**THE ATRIUM
REMODEL AT
THE VILLAGER
PHASE B-C-D**

SHEET NO.
A200

ATRIUM CAMERA PLANS
11/27/24 J. Whitney
12/6/24
2/5/26
2/27/26

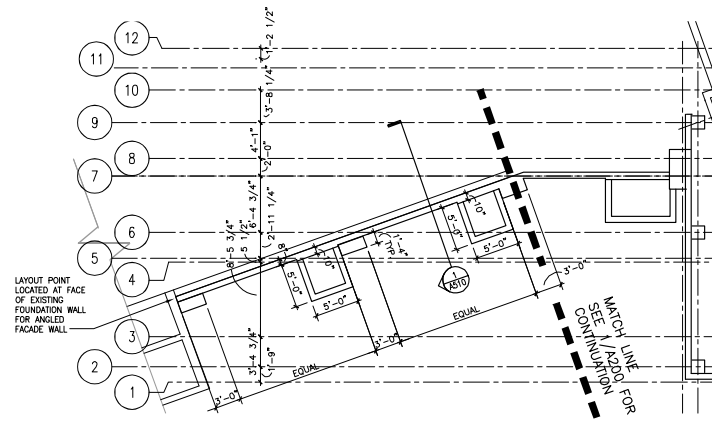
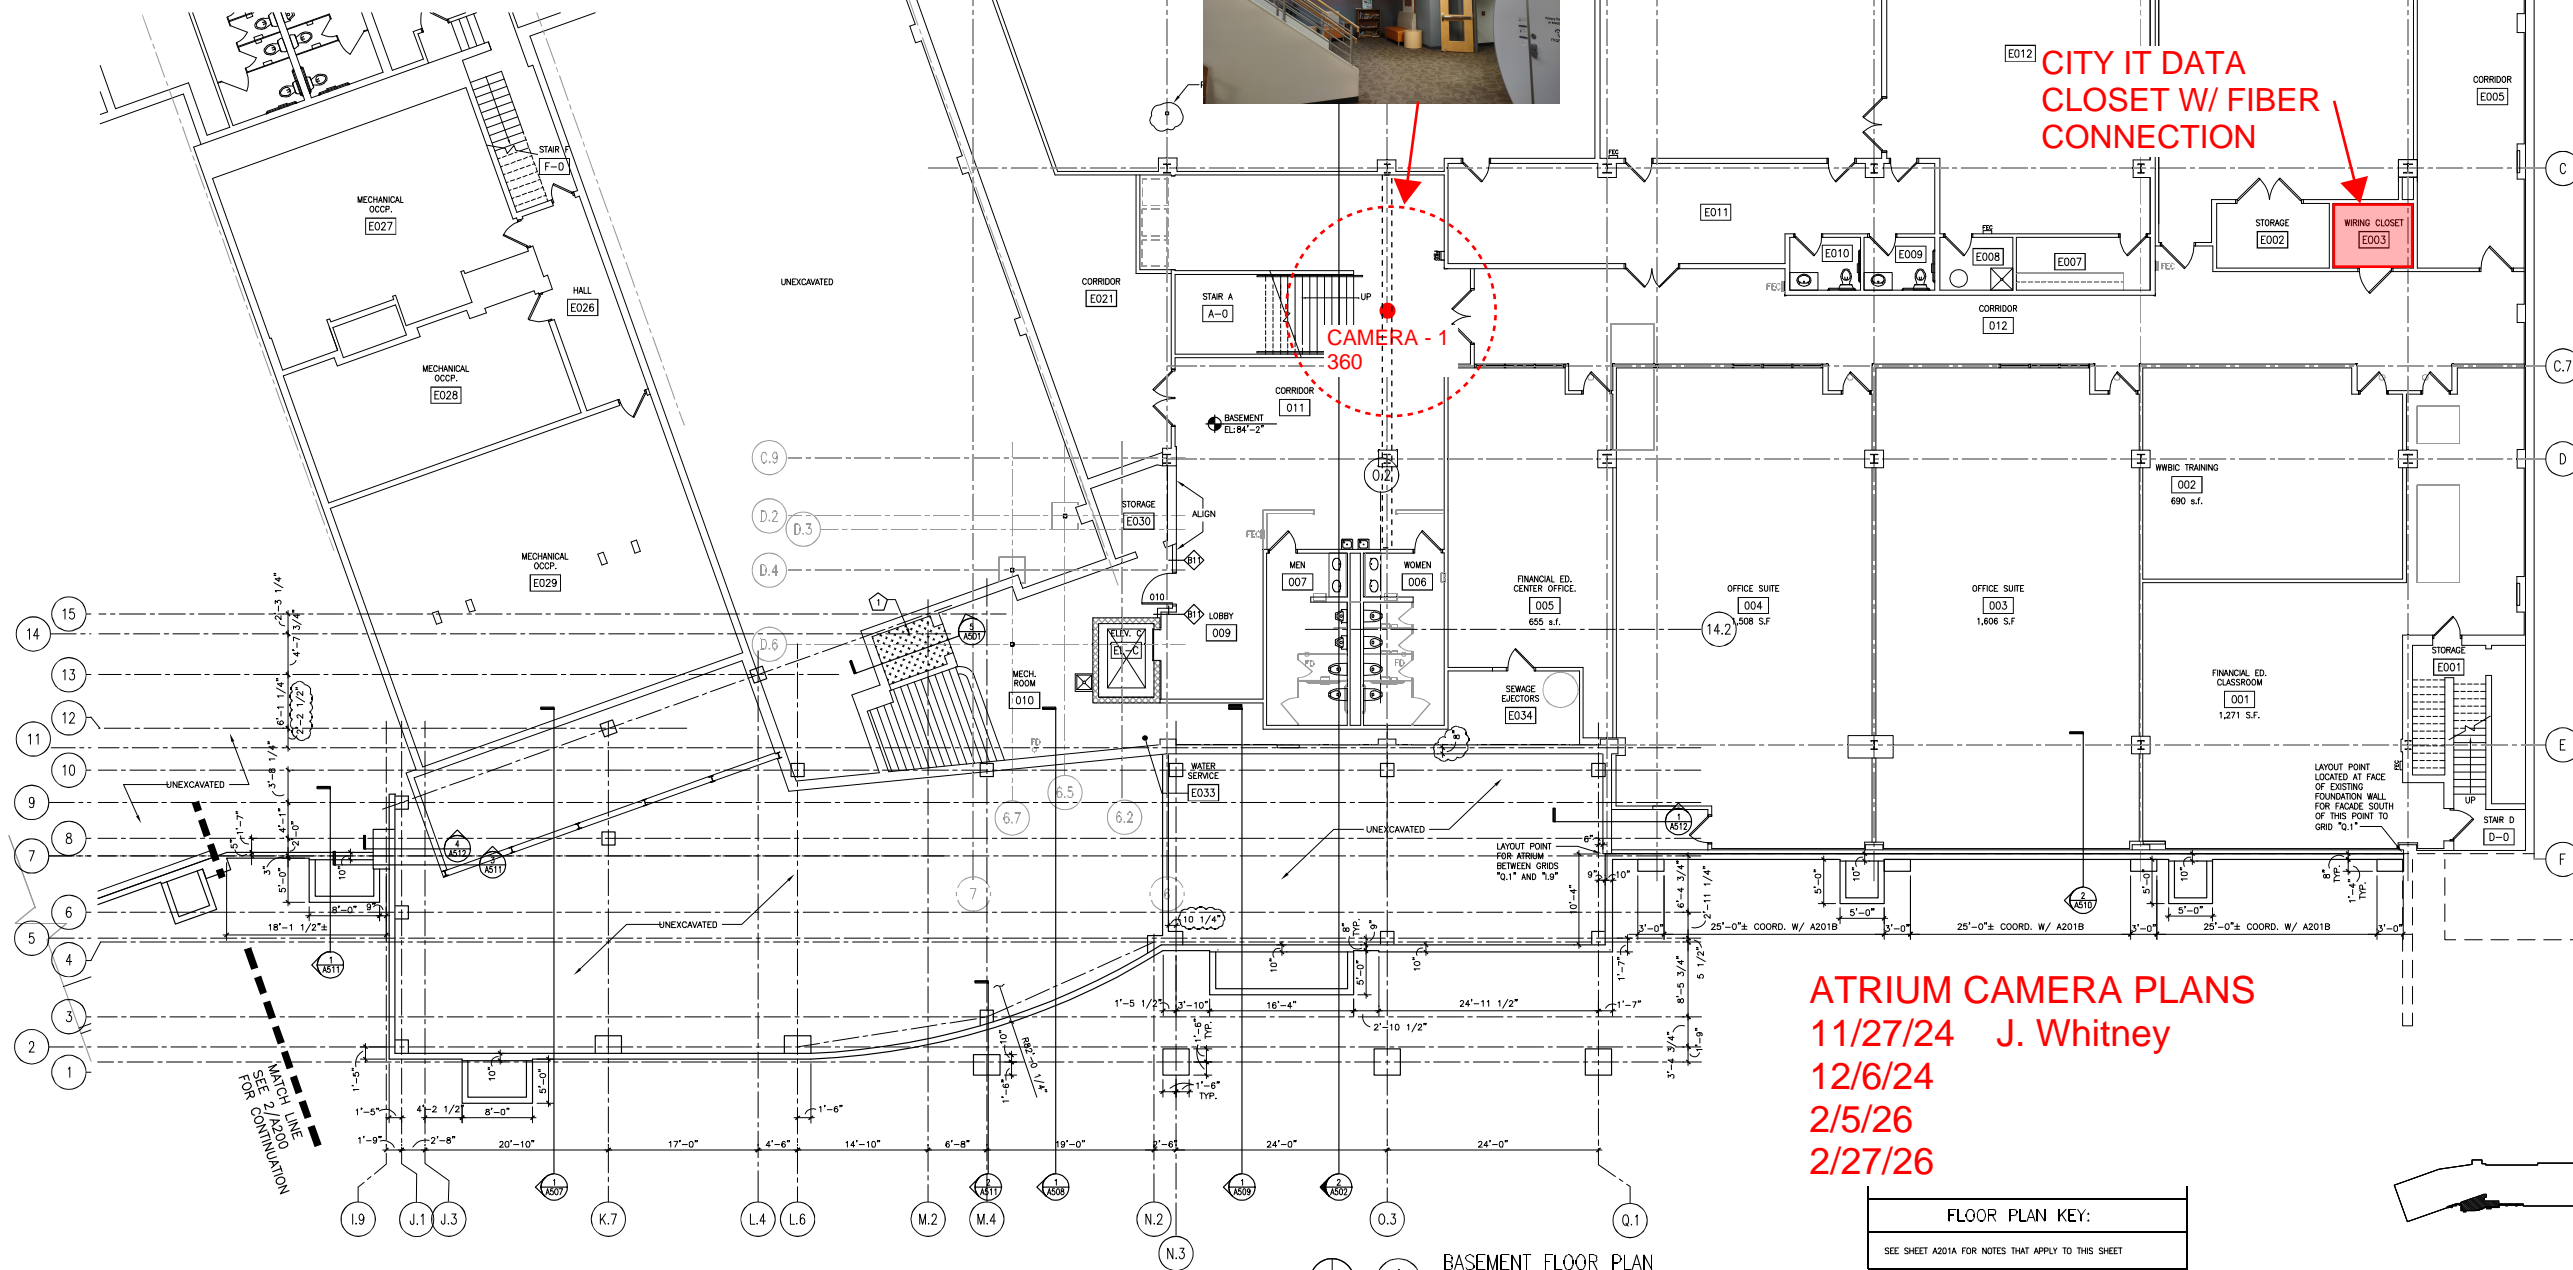
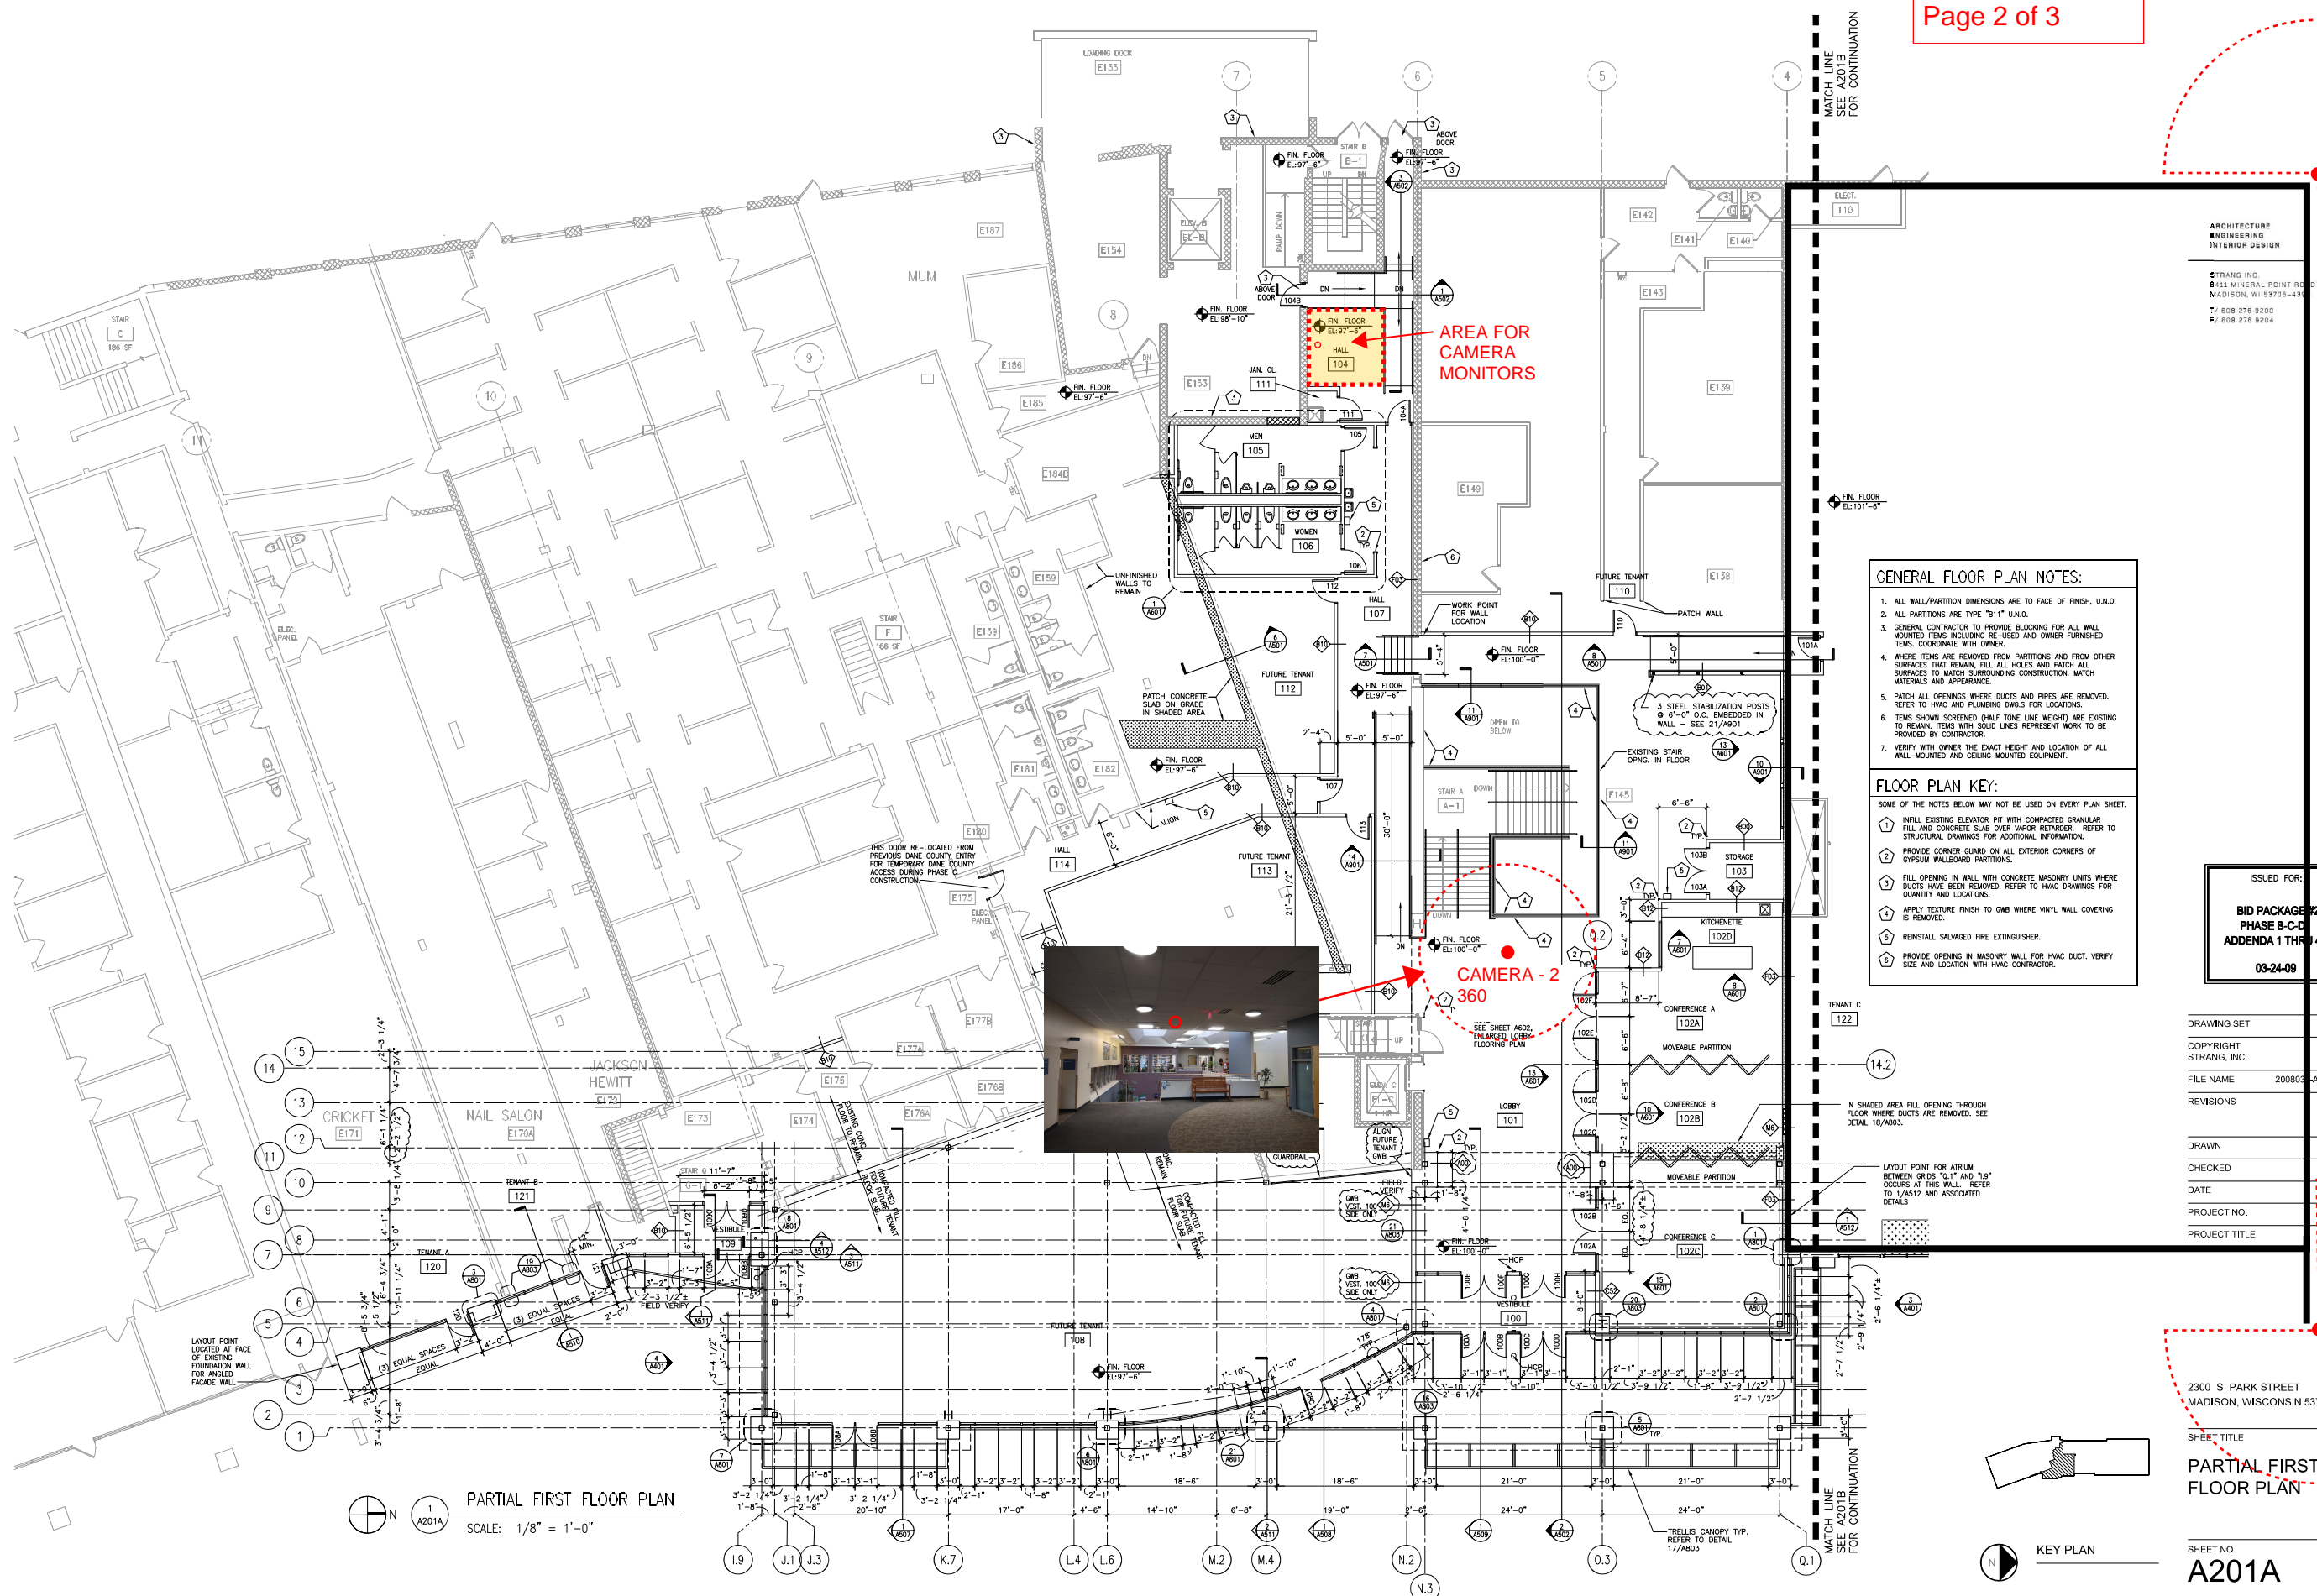
**FIBER CONNECTION
IN THIS AREA**

**CAMERA - 1
360**

**CITY IT DATA
CLOSET W/ FIBER
CONNECTION**
